ADDENDUM NUMBER 3

R17-28 Chemoy-Dogwood Watermain Install & Replacement

January 4, 2018

1297-C-01

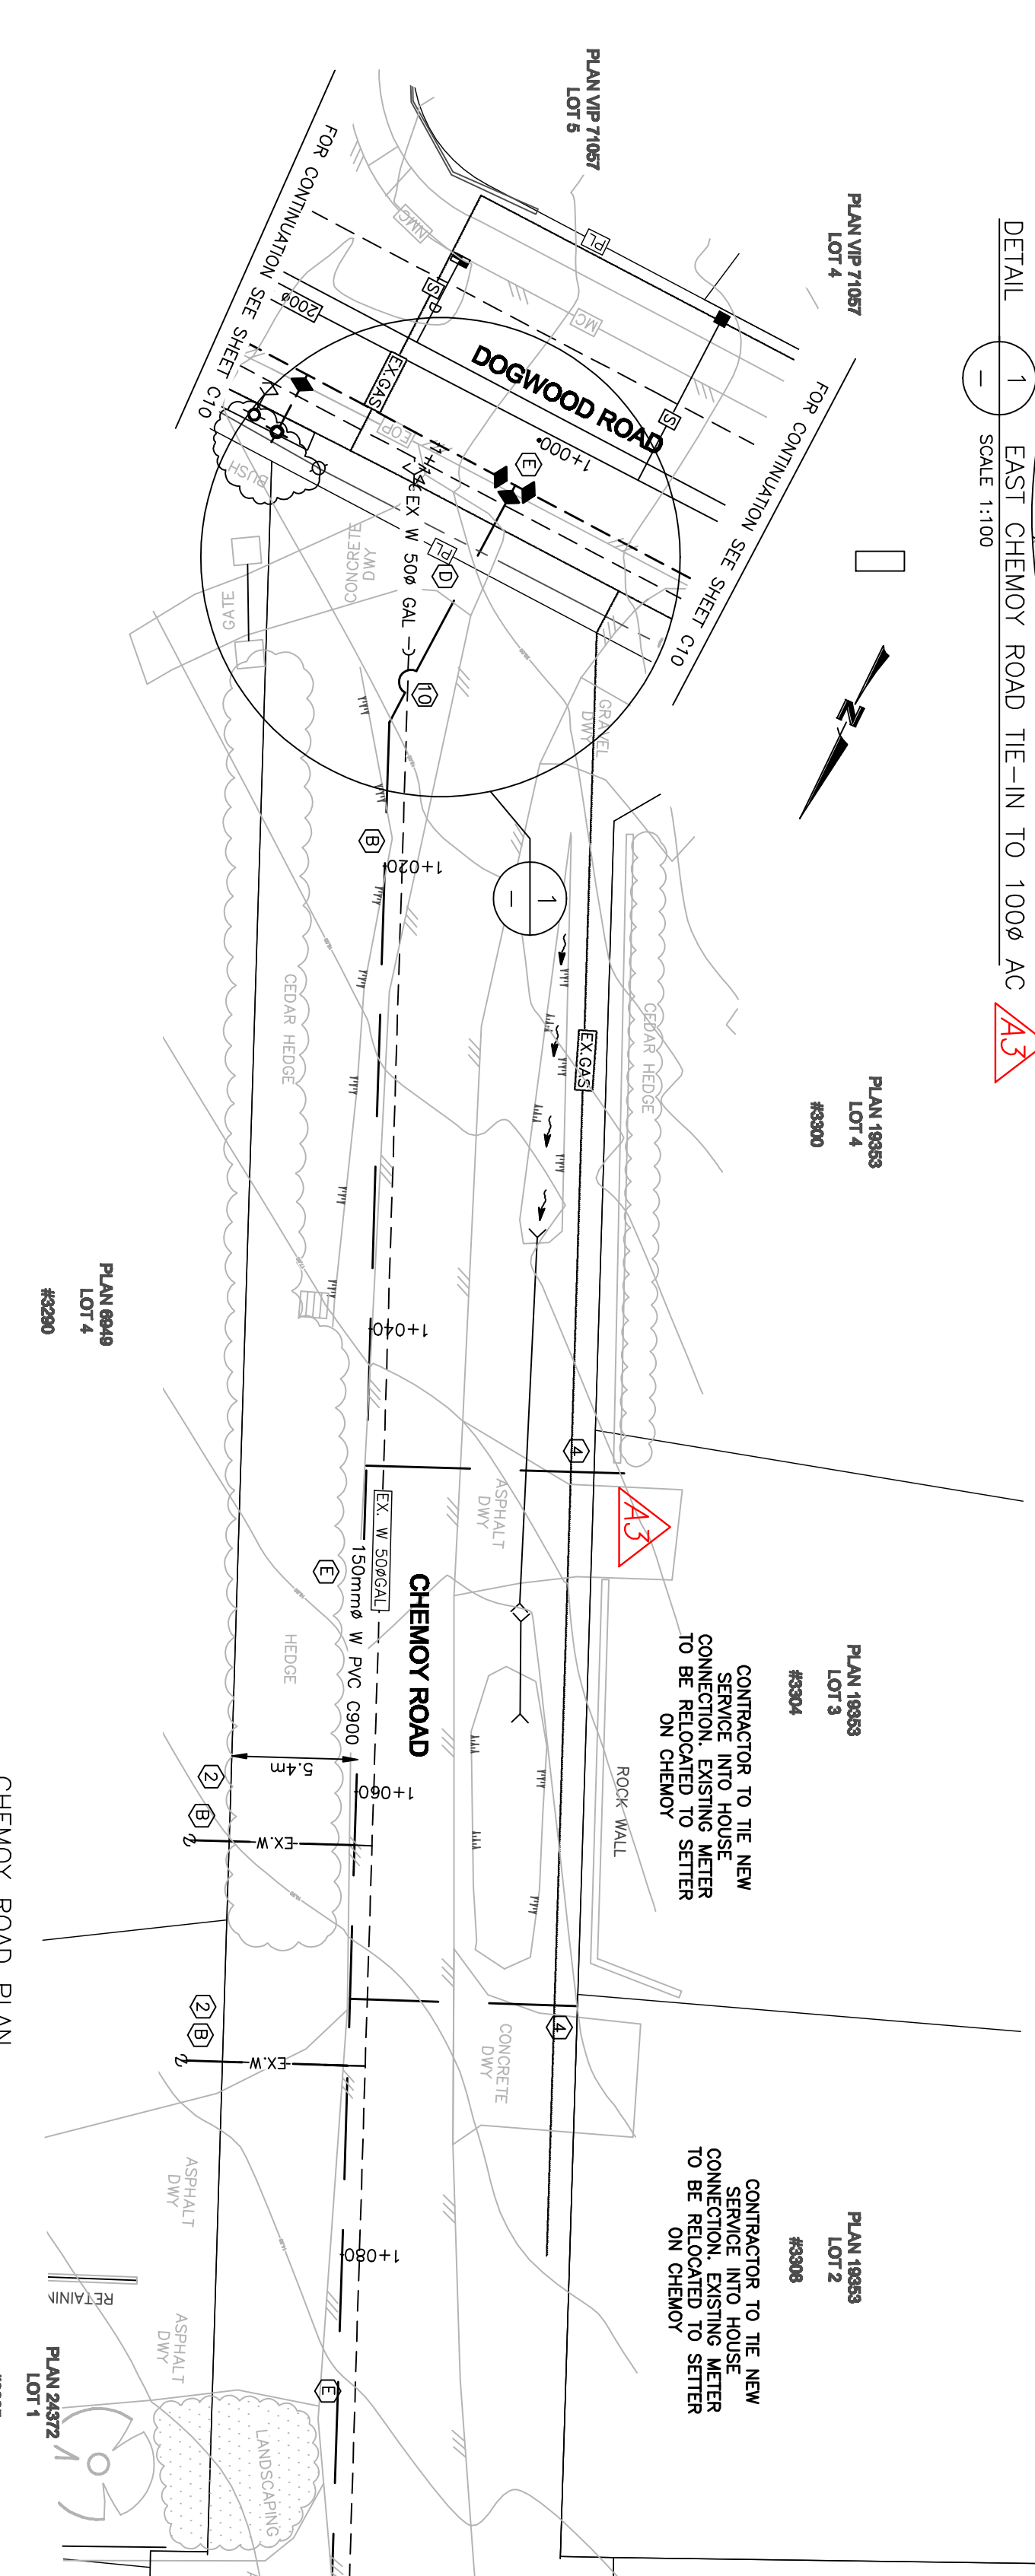
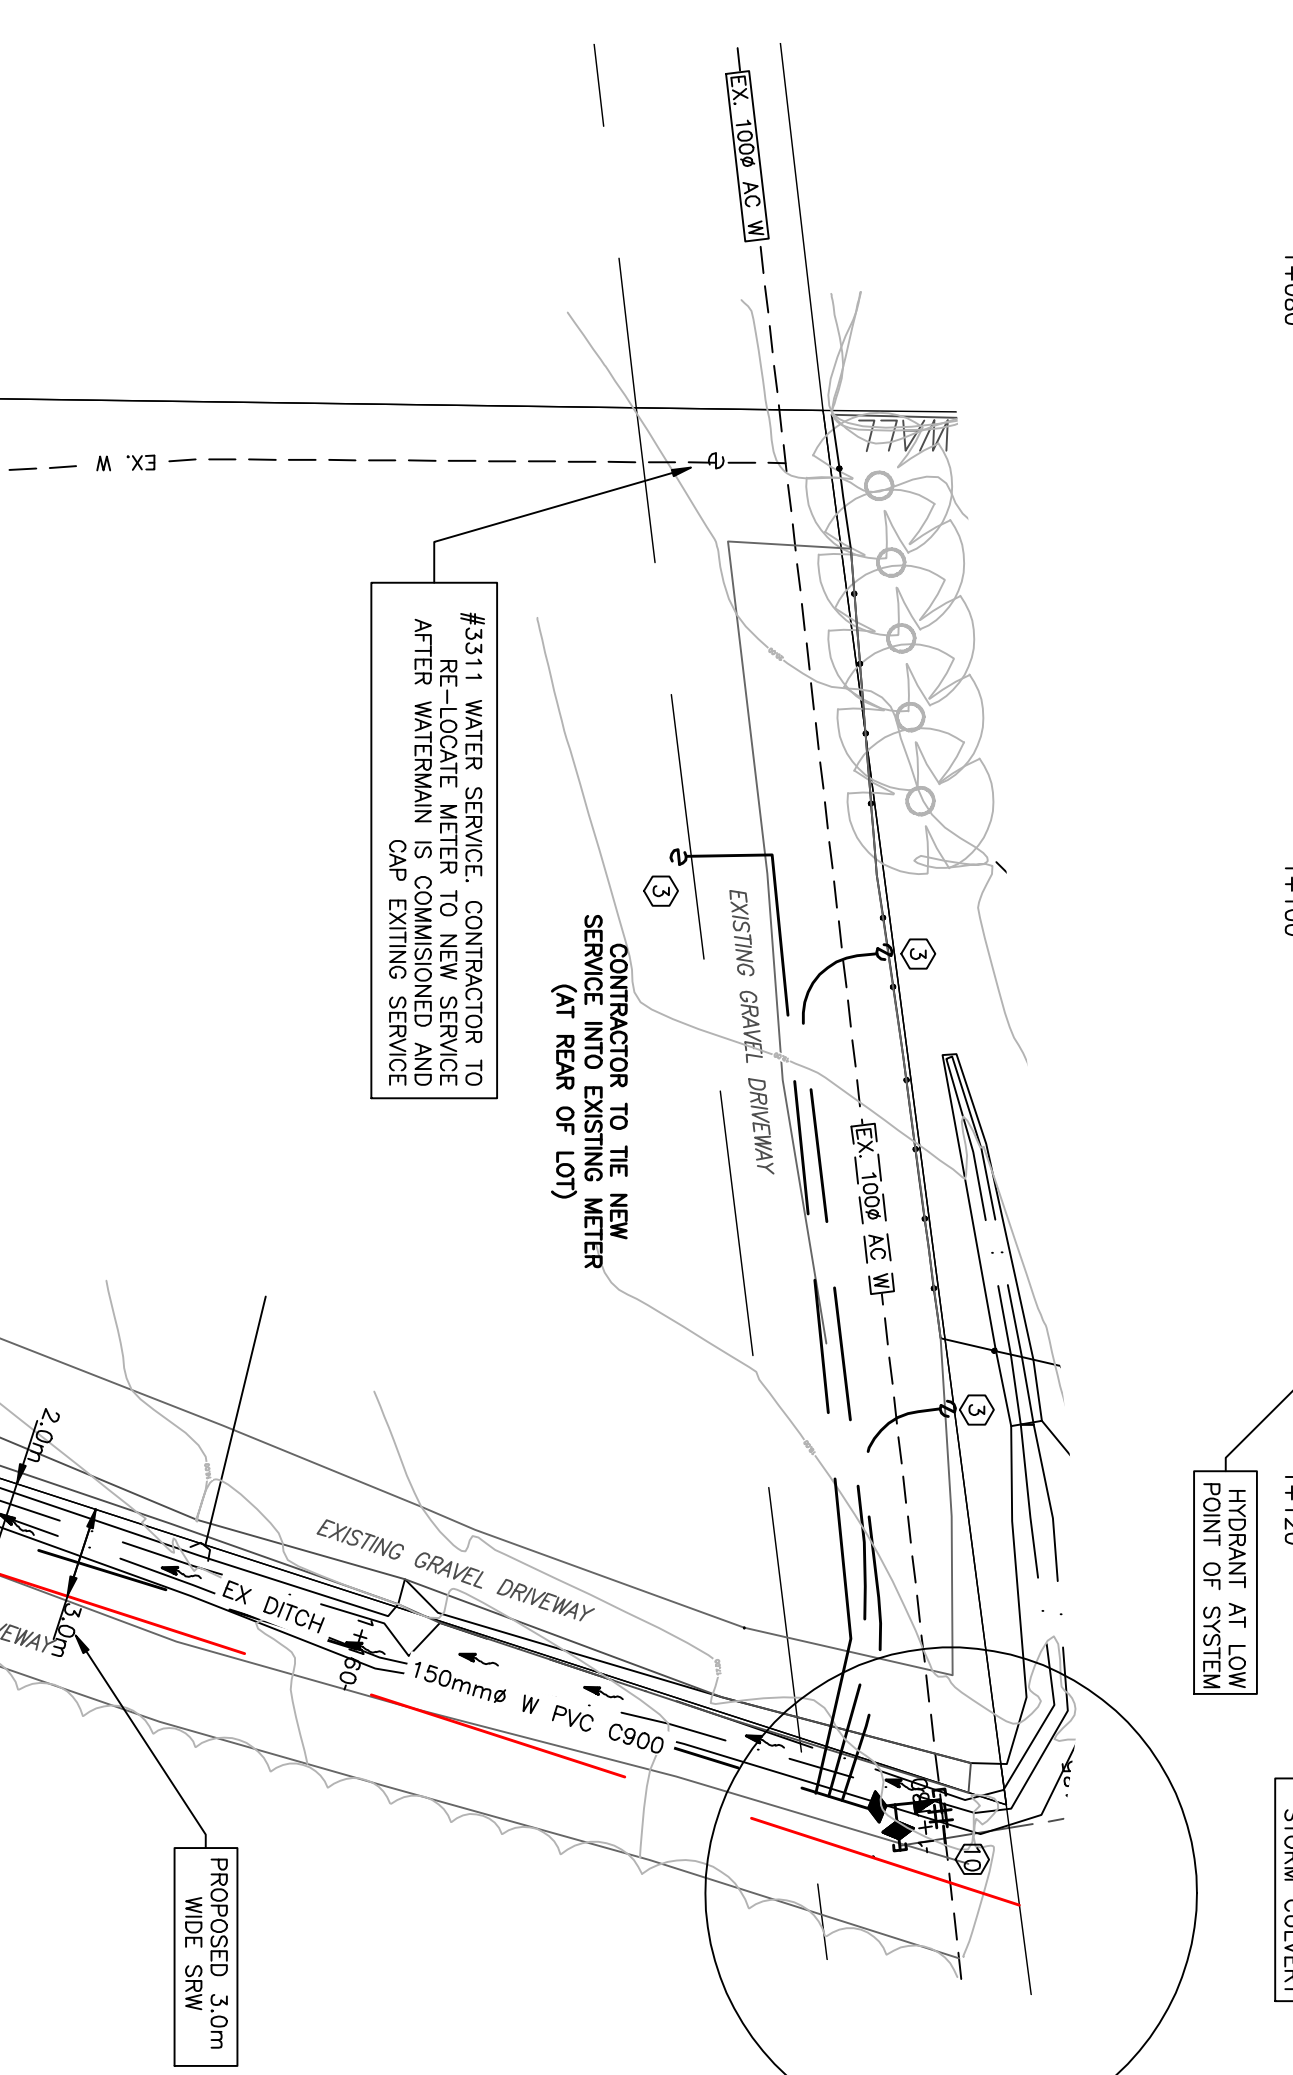
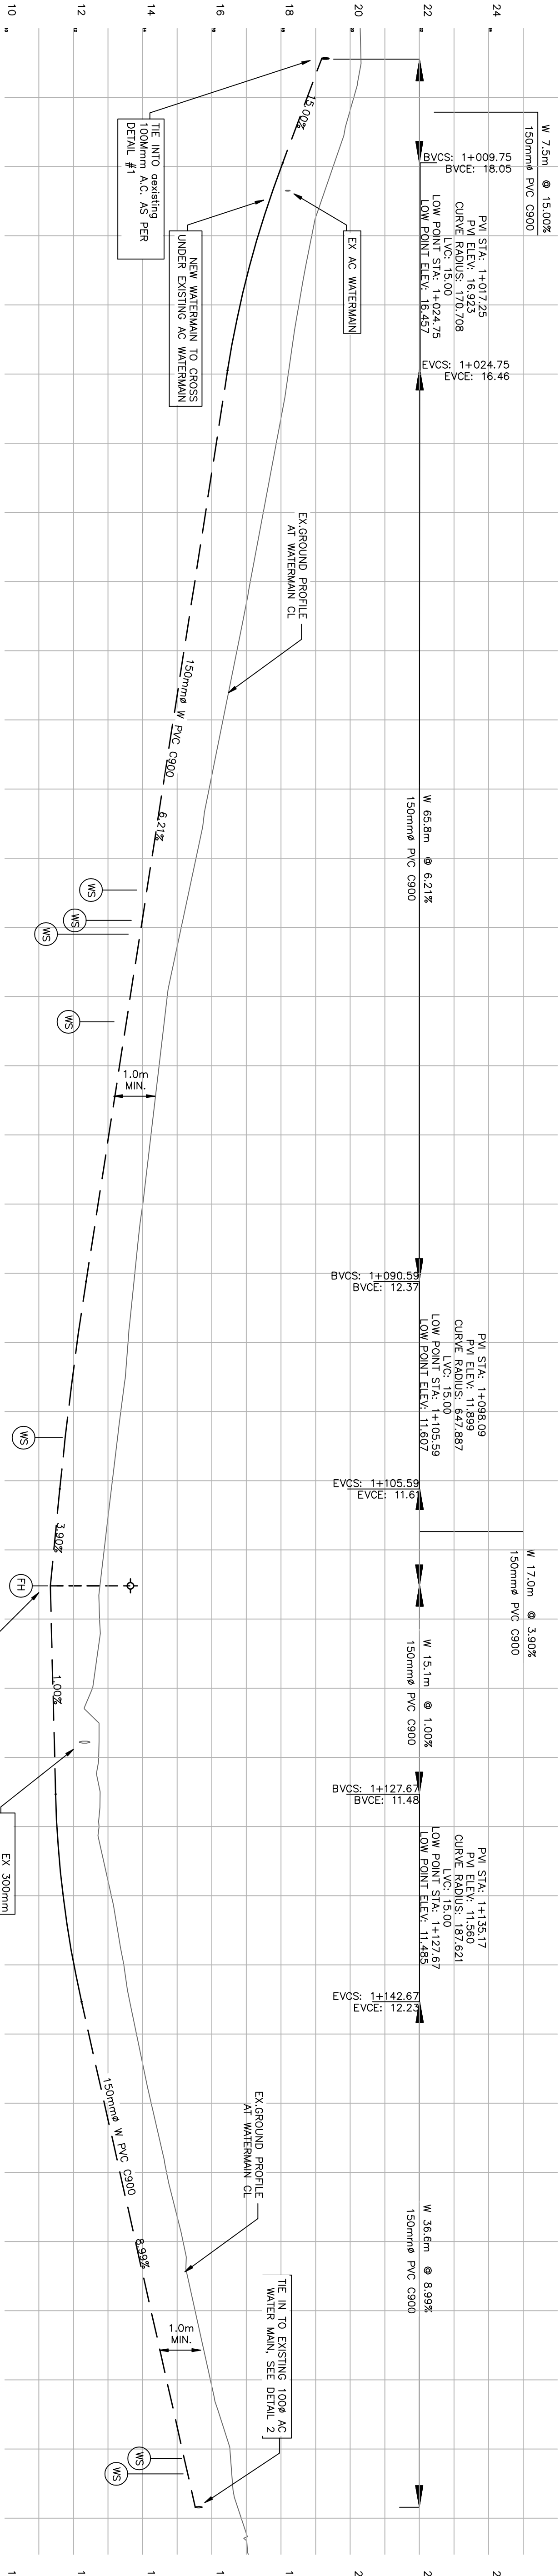
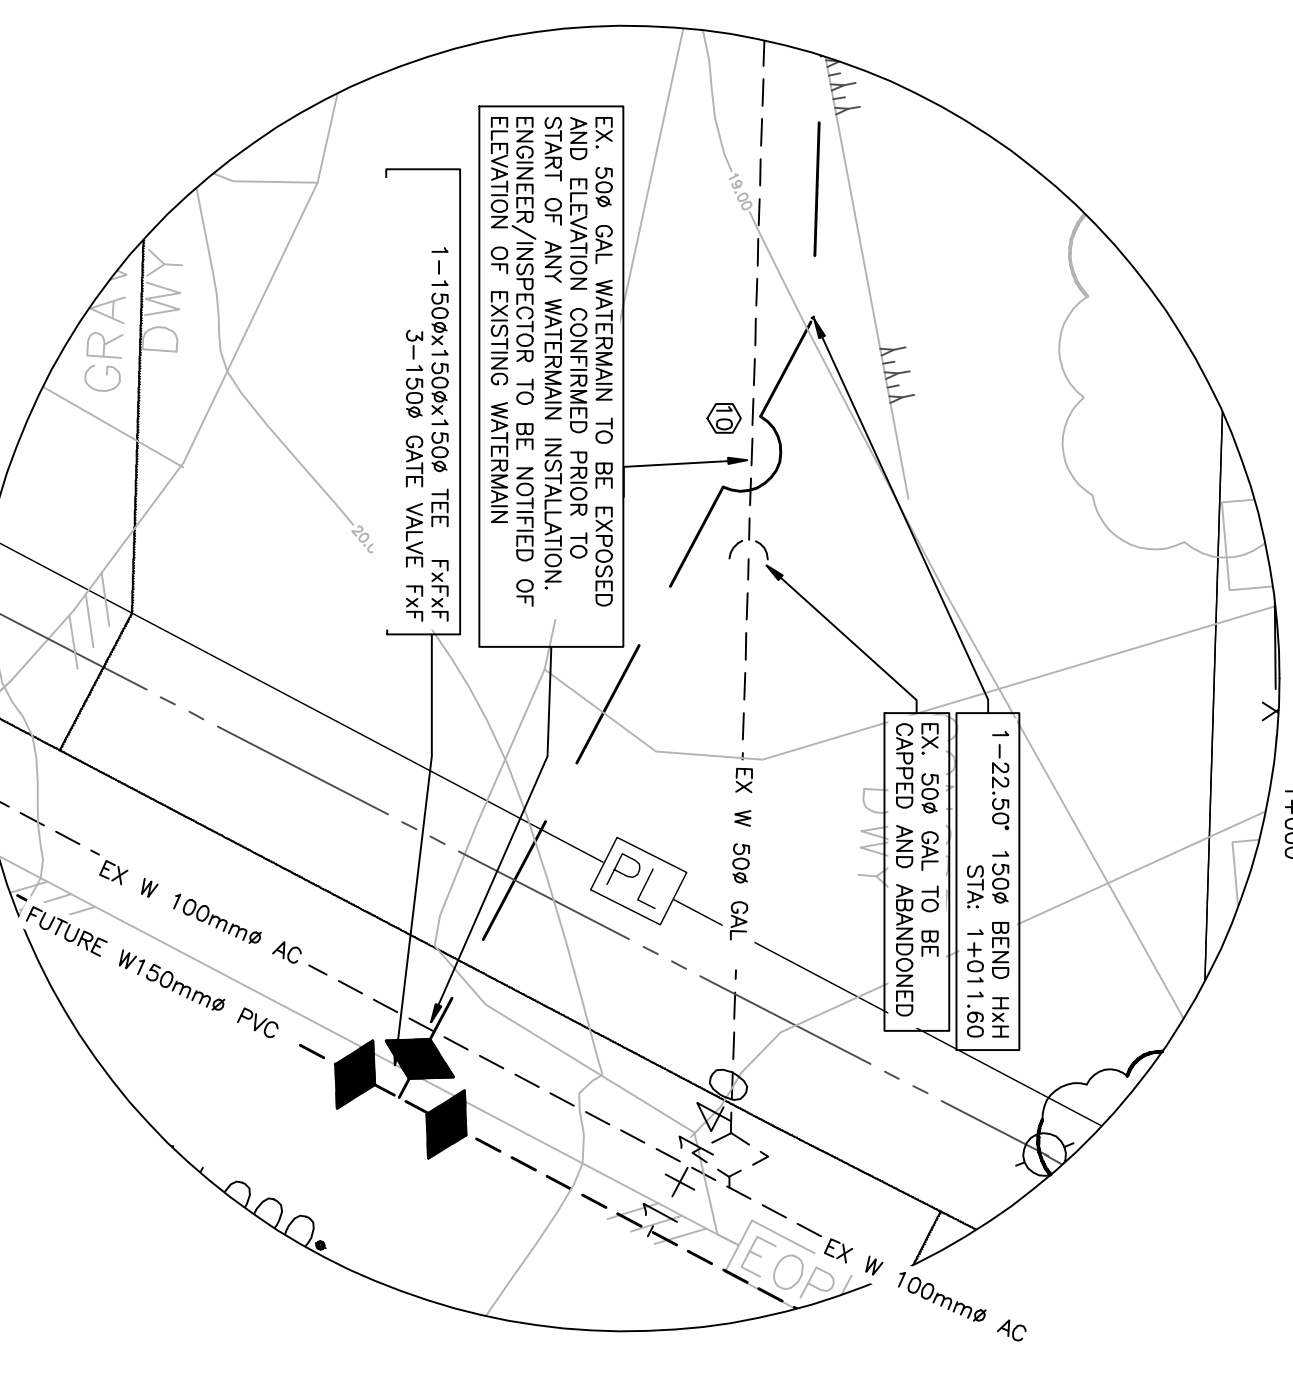
Q5. To reduce the cost of the services to #3304 and #3308 Chemoy Road, will the CVRD allow for pricing to include bringing the new service line to the front of the building only with the assumption that a plumber can reroute the water line internally bringing it to the front.

Q14. The existing watermain on Chemoy Road is shown as 50mm Galvanized Pipe, however at the tie-in location (Detail 1 on drawing 1297-C-01) it is shown as both 50mm AC and 100mm AC. Please confirm size of pipe and material.

A5. The alignment of the water service for 3304 Chemoy Road has moved to the opposite side of the property. The revised drawings shows the new alignment of the water service to the left of the driveway. All work is to be completed outside of the homes.

A14. The addendum #3 drawing will reflect the change.
